WASTE MANAGEMENT OF HAWAII, INC.
92-460 Farrington Highway
Kapolei, Hawaii 96707
(808) 668-2985

**RE: Solid Waste Management Permit Application
For renewal with Modification for Expansion, No. LF-0065-07
Waimanalo Gulch Sanitary Landfill
Located at: 92-460 Farrington Highway, Kapolei, Hawaii 96707**

On behalf of the City & County of Honolulu (CCH), Waste Management of Hawaii, Inc. (WMH), the operator of the Waimanalo Gulch Sanitary Landfill (WGSL), is responding to the Department of Health's (DOH) December 2, 2009 letter concerning comments to our expansion and renewal permit application and engineering design. WMH appreciates receiving and welcomes the opportunity to address DOH's comments.

FIGURE NO.	1
PROJECT NO.	WLD770
DATE:	DECEMBER 2009

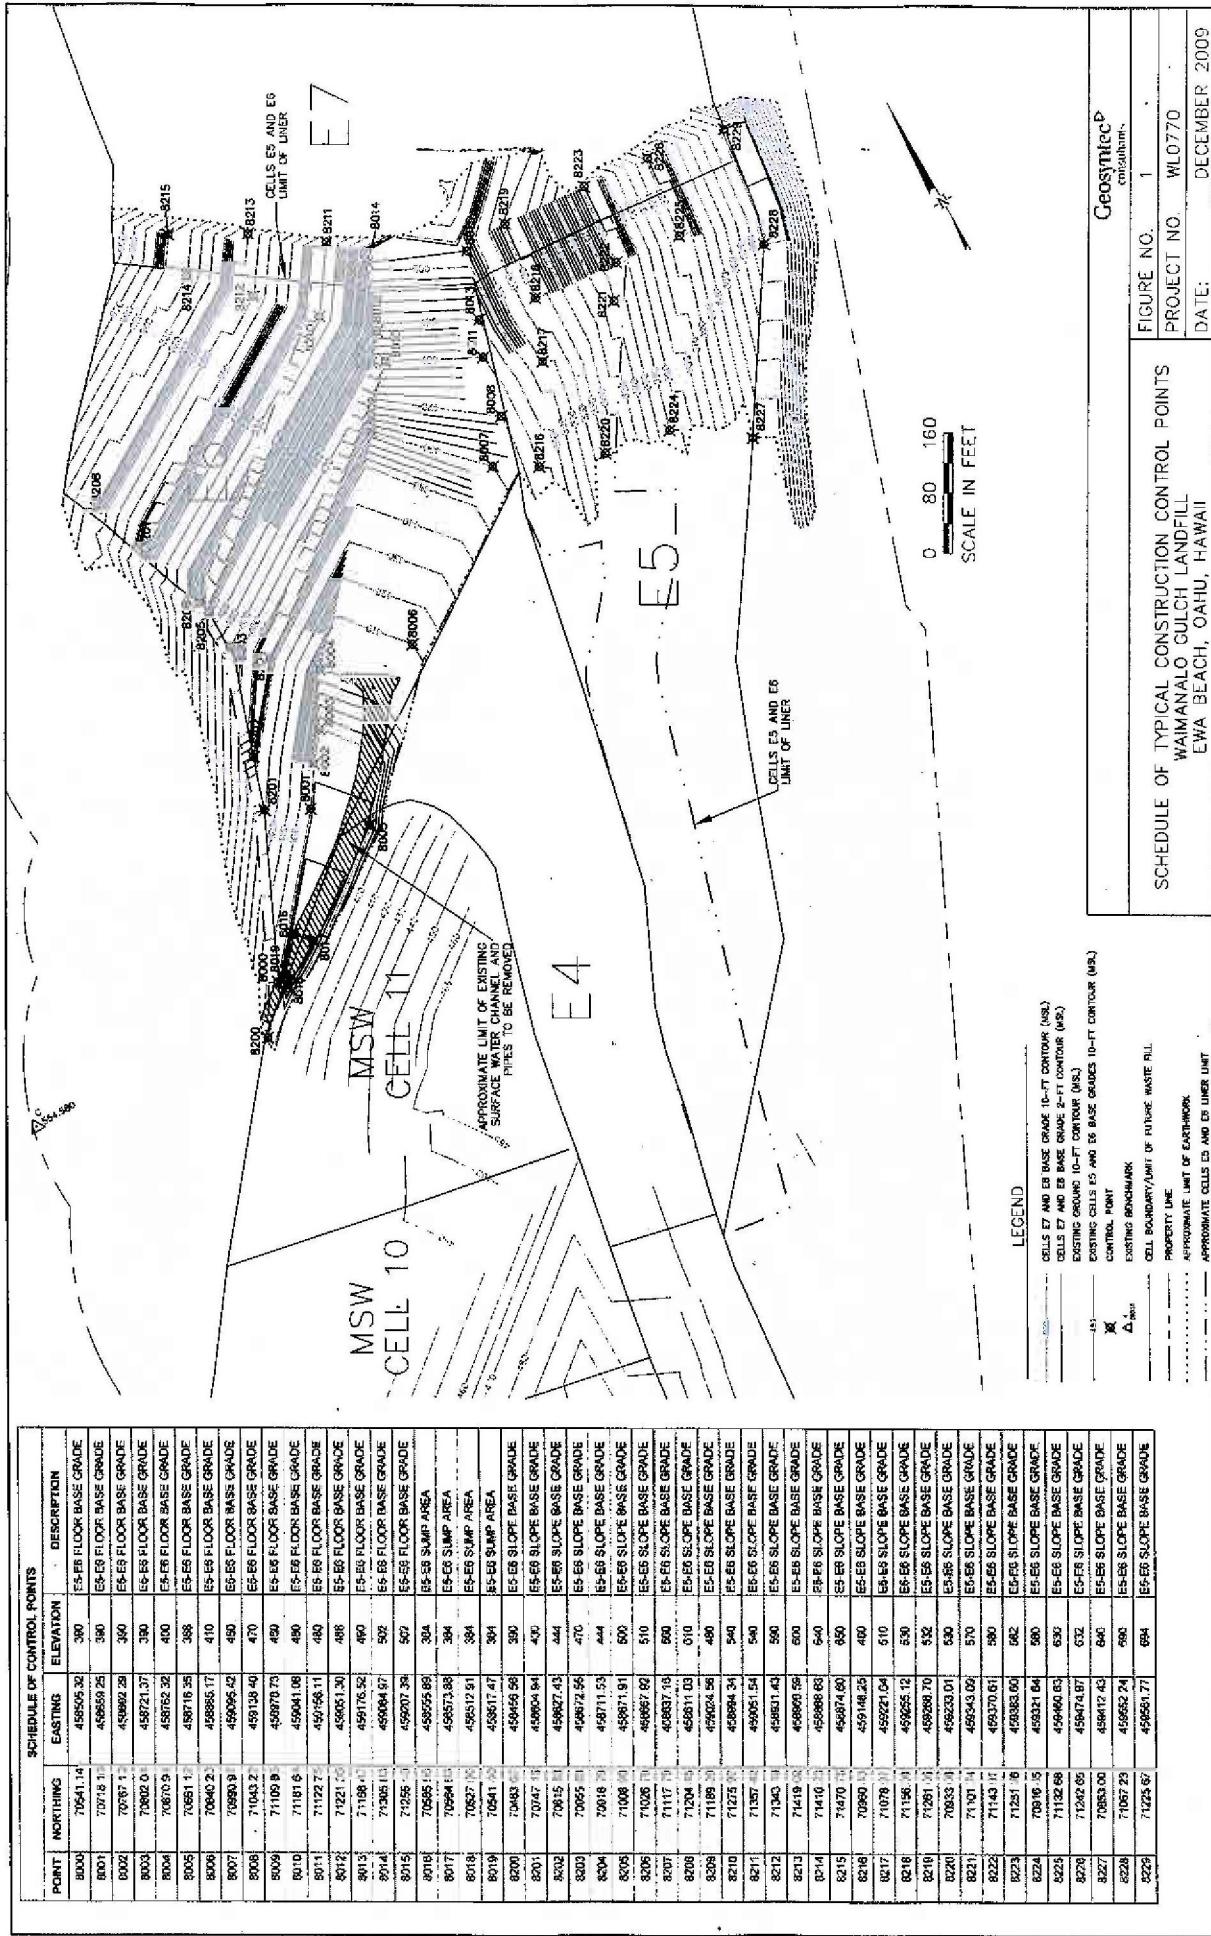
DOH Comment #1: *Survey control point matrices for the base grades for cells E5 and E6 were not provided.*

WMH Response #1: Due to advancements in technology, over the past few years, WMH's consultants such as Geosyntec Consultants, Inc. (Geosyntec) and GEI Consultants, Inc. and others have moved away from providing construction control points and instead have provided an electronic file (typically in Autodesk's AutoCAD Civil 3D) with the excavation and fill grades to the general contractors together with the construction drawing. Benchmarks are provided to the contractor for reference. This allows the contractor to: (a) import the electronic file directly into the global positioning system (GPS) which is set up on the construction equipment for the construction project, (b) create a model/layout that he/she provides to the consultants for confirmation, and (c) provide the information to the project's surveyor so the surveyor can layout the job and check the grades as construction progresses. This is now the practice on most projects we work on and has resulted in greater efficiency and accuracy in project construction execution.

To respond to DOH's request, we are also providing a list of key control points as shown in Figure 1.

Figure 2 - Temporary Surface Water Control

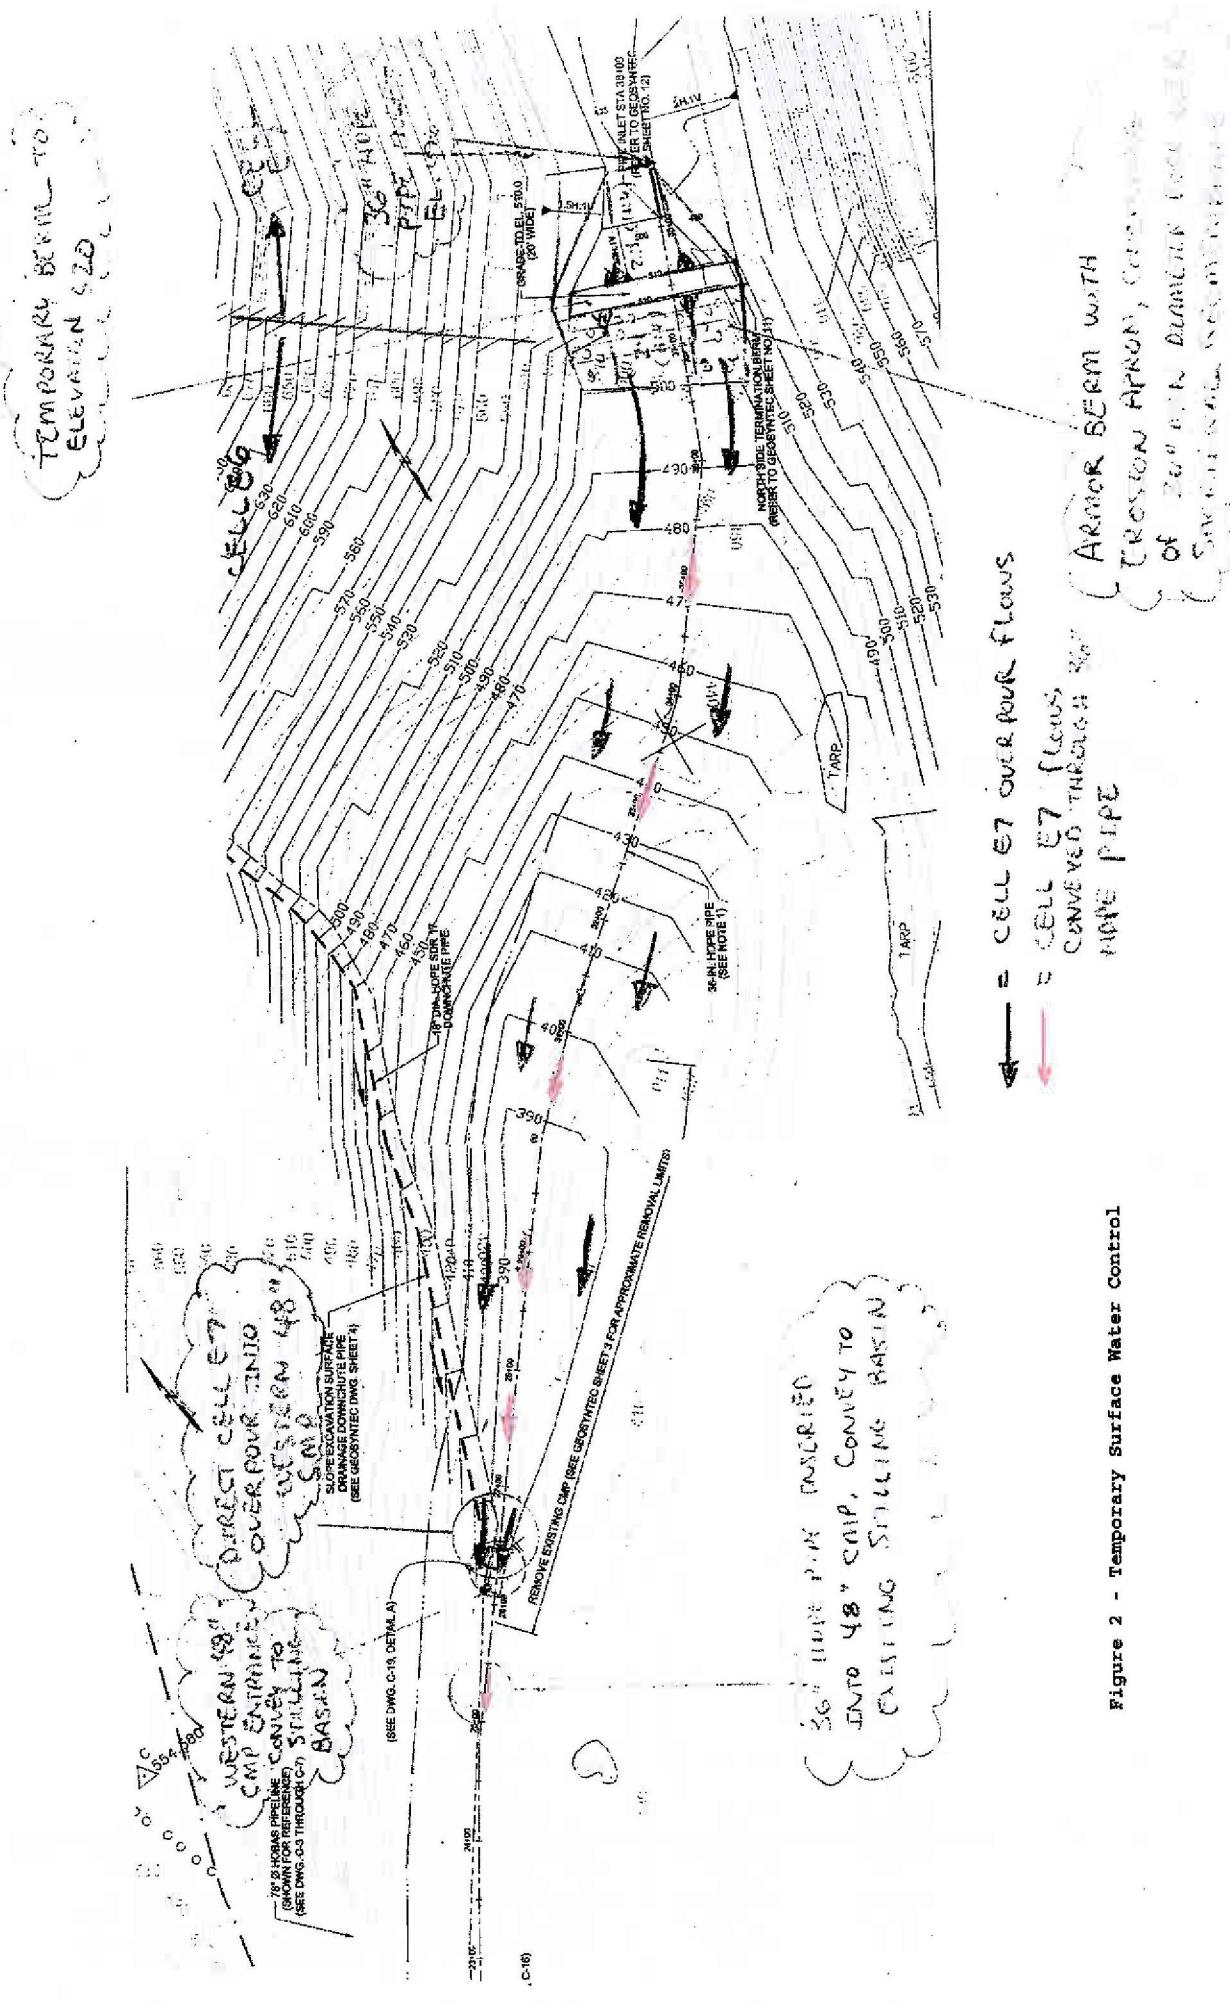
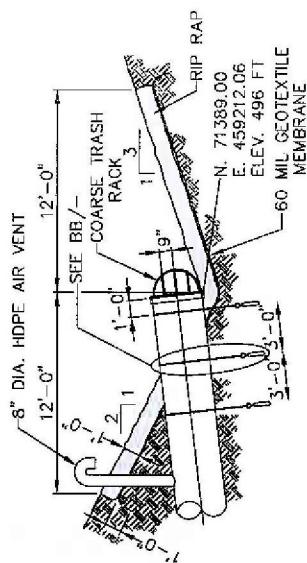
DOH Comment #5: *The subdrain trench design does not agree with the planned western drainage system that was previously presented in the Engineering Report for Landfill Expansion, prepared by Geosyntec, Inc., and dated March 12, 2008, and in the Western Surface Water Drainage Project, prepared by DEI Consultants, Inc. and dated June 2009. The installation of such a large (7 feet high by 12 feet wide) trench with pipes under the base liner was unexpected, and raises concerns including, but not limited to the ability of the temporary stormwater drains to handle 25-year 24-hour storm flows. We assume that this portion of the stormwater system will be in operation before the entire western drainage system is constructed. In addition, the new HDPE surface drain pipe inlet details shown on sheet 12 show that compacted fill will be used to support the inlet structure. The grading drawings do not show the configuration of berms or other earthen structures that would be needed to serve as headwalls for the inlet structures. Since the existing surface drainage from above the landfill uses two 48-inch CMPs with about an 8 to 11 foot high headwall and an overflow channel above the pipes, it appears that the proposed 30-inch and 36-inch HDPE pipes may not be adequate to handle peak storm flows without an overflow capability. Please include the headwall design and explanation of how overflows will be avoided during peak flows in the updated drawings.*

WM Response #5: WM has developed a plan for the temporary diversion of natural site run off during the period of time prior to completion of the Western Drainage system. There will be a period of several months in the late spring and summer prior to completion of the Western Drainage system when potential storm water inflows from Waimanalo Gulch would report to the areas of Cells E6 and E7. As can be observed on Figure 2, the plan includes the following:

- A temporary berm at Elevation 520 in future Cell E7 to create a small detention pond outletting to a new 36-inch diameter HDPE pipe which will be constructed along the floor of Cell E6 as part of surface water control during landfill operations.

- At the southern end of Cell E6, the 36-in pipe will be inserted through the eastern-most, existing 48-inch diameter CMP temporary pipe under the currently-constructed West Berm. The 36-inch pipe will be routed inside the 48-in diameter CMP and into the existing concrete channel and stilling basin. In the event of a larger storm inflow during the construction period, the stormwater would be routed over a protected section of the temporary berm into the E6 cell which would provide supplemental storage to control off-site drainage.

- As a precaution, WM will deploy a temporary 6 mil sacrificial geomembrane over existing waste-filled areas to control stormwater contact with the currently-placed MSW and minimize the amount of water that can percolate into the waste. The sacrificial geomembrane will be deployed in advance of a forecasted major storm event as a contingency.

- Also, as a precaution, the southern portion of the temporary berm at Elevation 520 will be surfaced with an erosion apron consisting of an HDPE liner overlain by on-site rock materials to minimize erosion damage to the temporary berm.

- Excess pondage would be routed back to the 36-in HDPE pipe for drainage as stated above or into the existing western 48-inch CMP for routing down the existing concrete channel and into the stilling basin. Therefore, the western 48-inch CMP under the West Berm will remain open to receive storm inflows that exceed the capacity of the 36-inch pipe.

- After the waste covers the entire expansion area and the northern portion of the run-on control channel has been completed, the 36-inch pipe will be abandoned and grouted shut.

Details of the temporary drainage provisions are shown on attached Figure 2. These types of temporary drainage provisions are commonly used on diversion projects during short windows of time prior to completion of permanent water diversion projects. We believe the above plan maintains positive drainage at the site, has provisions to handle larger flows including a 25-year 24-hour event, and is the most cost-effective option. Since the majority of the Western Drainage system work will occur during the late spring and summer, the risk of larger winter storms is lower. We anticipate that during smaller storm events, storm inflows will be contained within the future Cell E7 area and conveyed through the new 36-inch HDPE pipe without flowing into Cell 6 and impacting the downstream areas.

Geometric □	
FIGURE NO.	3
PROJECT NO.	W0070
DATE:	DECEMBER 2009

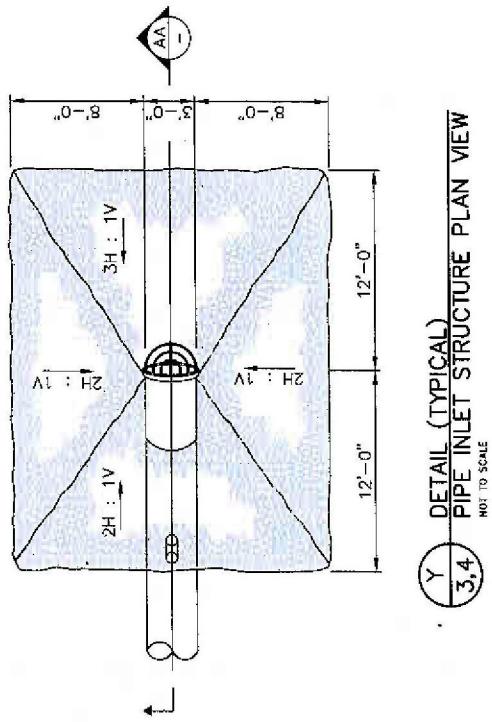
DOH Comment #6: *The submitted permit drawings for the temporary surface run-on drainage show 30-inch and a 36-inch running under the base liner in Cell E6 and connecting to the existing 48-inch CMPS below the Cell E6 lower boundary. Drawings received via email on October 14, 2009 prepared by DEI Consultants, Inc. and forwarded via WMH show how the proposed 84-inch Hobas pipe of the western drainage system will tie into the existing concrete drainage channel under the area of the proposed stockpile. This drawing shows one 48-inch CMP will be cut and plugged, and a 36-inch HDPE pipe running out of the other 48-inch CMP. This leaves questions as to whether the 30-inch and 36-inch HDPE pipes are to connect to the existing 48-inch CMPS or are to run inside the CMPS, and what happened to the 30-inch HDPE pipe. Please clarify.*

WM Response #6: Please see the response to Comment No. 4. The 30-inch HDPE pipe will no longer be installed. The temporary surface run-on control will now consist of a single 36-inch HDPE pipe located beneath Cell E6 and inserted through the eastern 48-inch CMP culvert downstream of Cell E6. Figure 3 shows the inlet structure for the drainage pipe.

Geosynec [®] Contractors	
FIGURE NO.	4
PROJECT NO.	WEQ770
DATE:	DECEMBER 2009

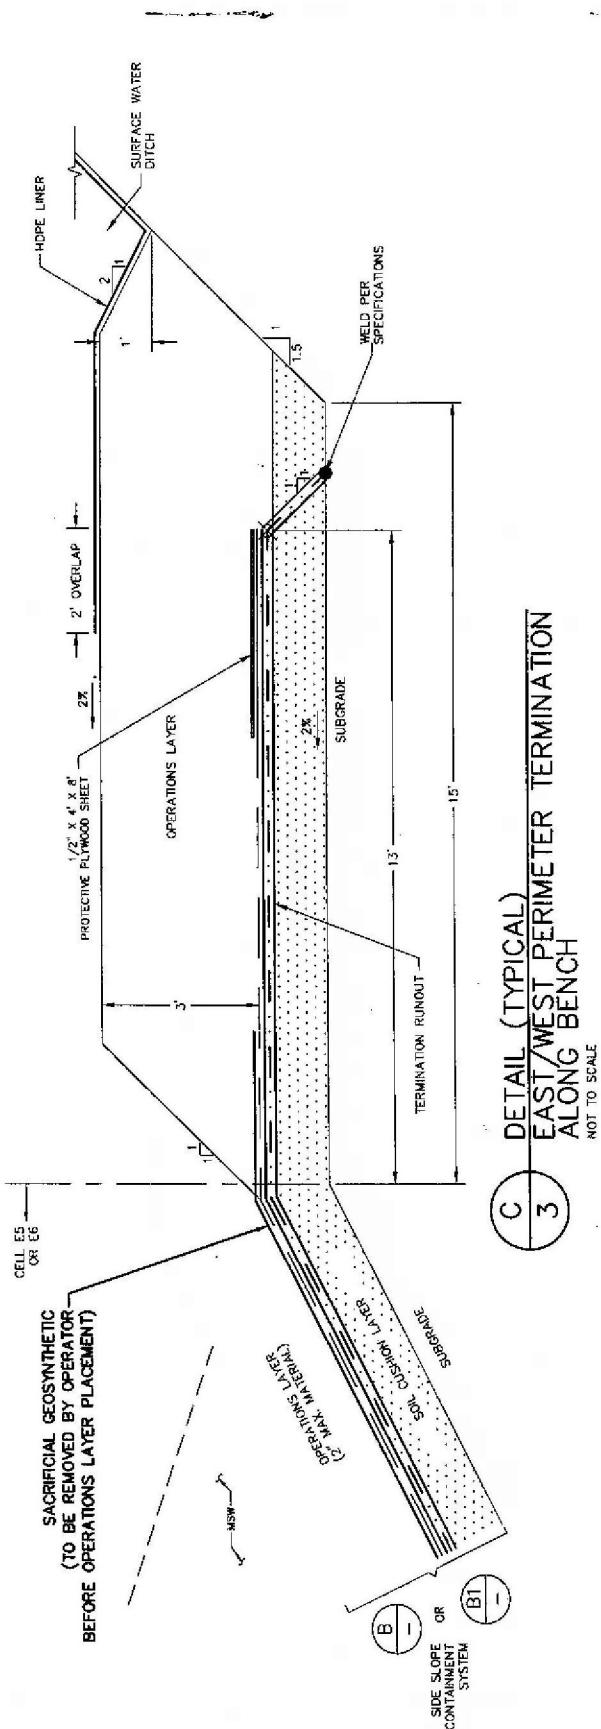
DOH Comment #7: *The east/west perimeter termination of the base liner in Cells E5 and E6 are not designed to prevent surface water infiltration under the liner, based on the drawing, Detail C/5. The liner terminates short of the 2 feet overlap from the upstream end of the bench, which will allow water to infiltrate through the operations layer to travel under the liner, which could impact the quality of liner downstream, particularly of existing lined sections. We suggest that the HDPE liner for the surface water ditch be extended to create a minimum of 2-feet overlap over the underlying liner system, to prevent surface water to seep beneath the liner. We note that the expansion liner system contains a lower 40-mil HDPE liner; however, the downstream Cells E4 and 11 do not.*

WM Response #7: As requested by HDOH, Figure 4 shows the revised liner termination at the bench which will also be included in the Construction Drawings. As can be observed, the HDPE liner for the temporary surface water ditch has been extended to achieve the requested 2 ft overlap.

Figure 5 – Cell Layout

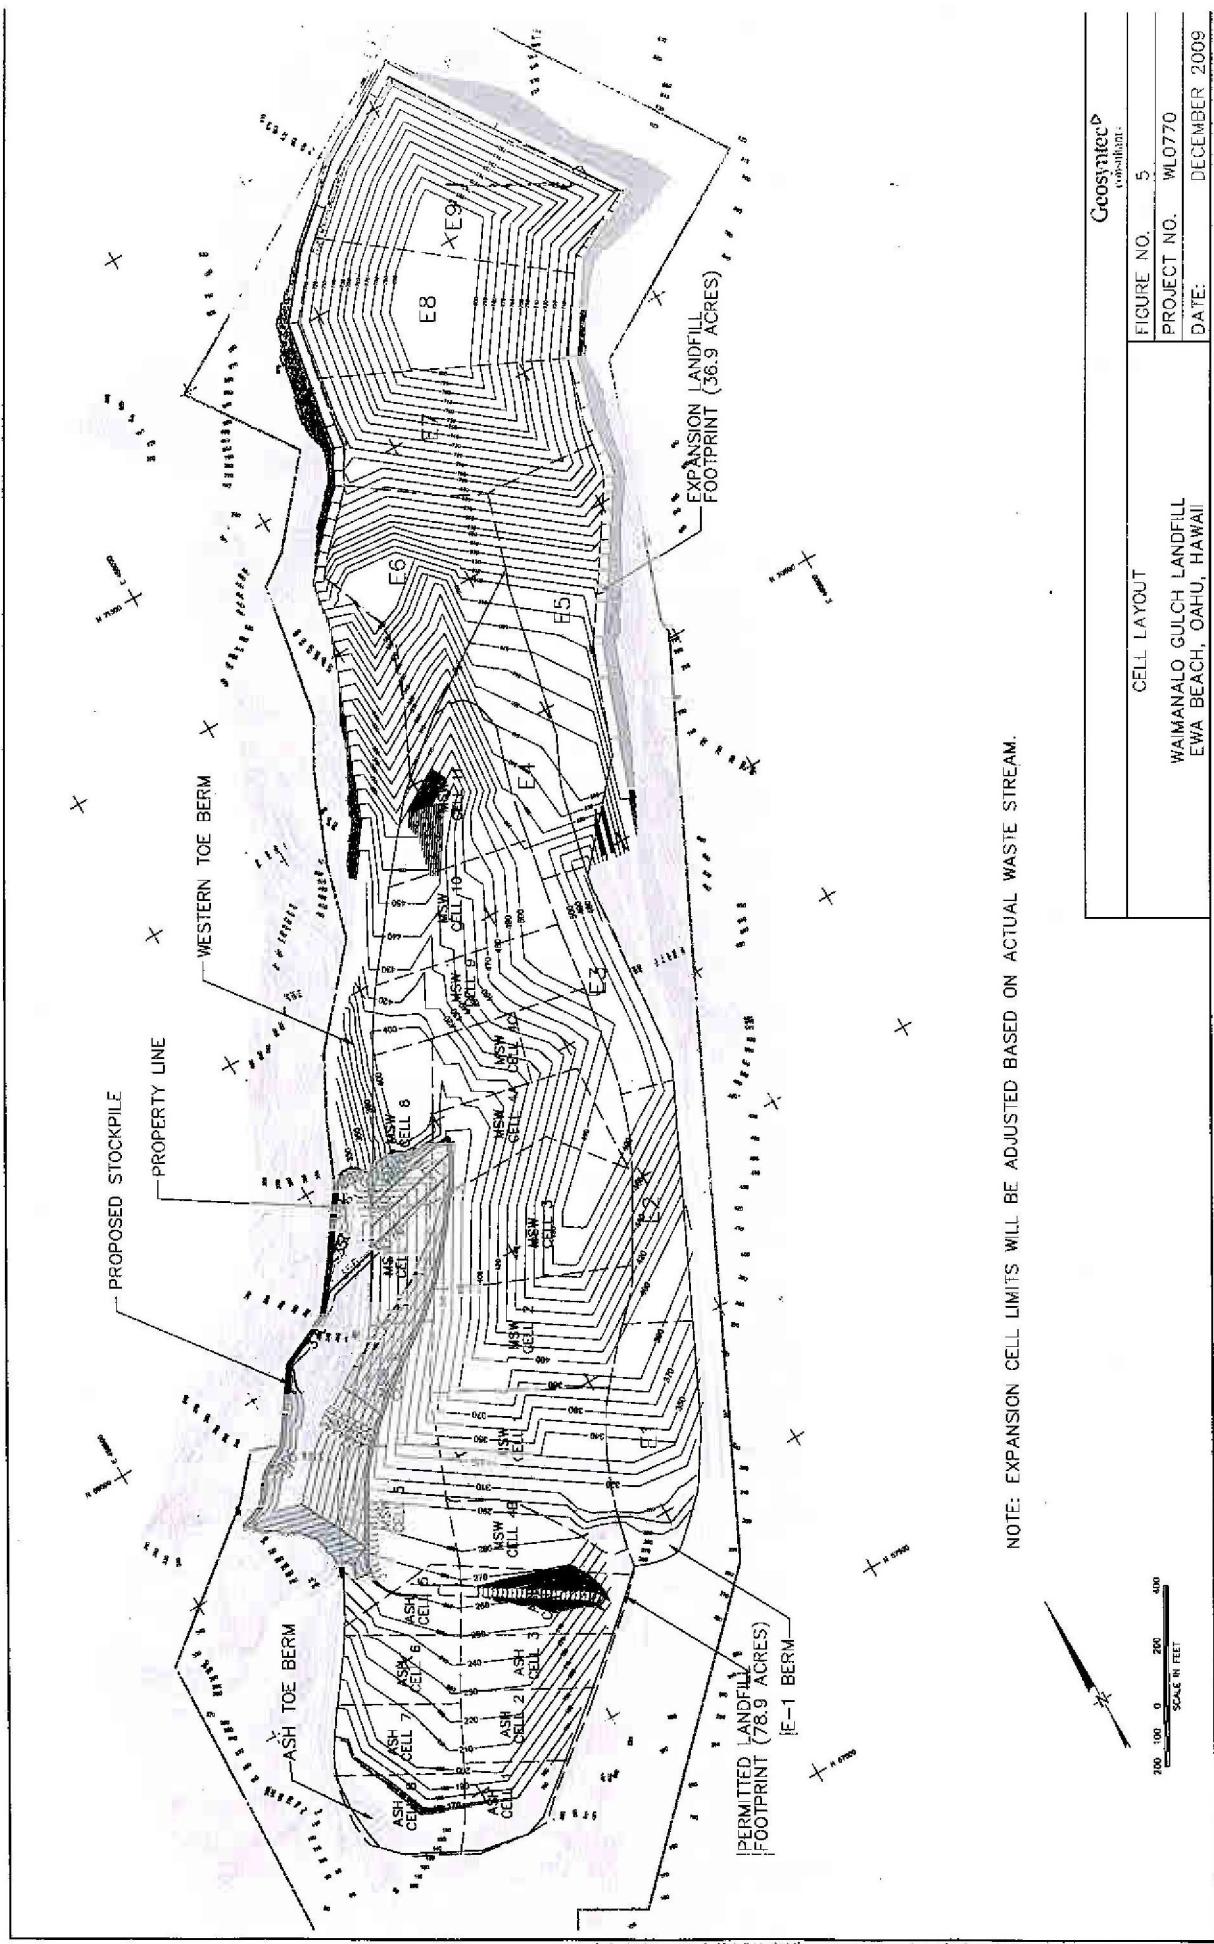
DOH Comment #10: *Drawings for E5/E6 plan show a different cell layout from the engineering report drawings in the original application. Even this engineering report for E5/E6 stability analysis makes reference to E5 to E11 as expansion cells while the referenced drawing only goes to E9. For permitting purposes, these descriptions need to be consistent.*

WM Response #10: Attached Figure 5 shows the current cell layout; for reference, Figure 6 of the *Revised Engineering Report for Landfill Expansion* dated 24 November 2009 prepared by Geosyntec shows the updated cell limits.
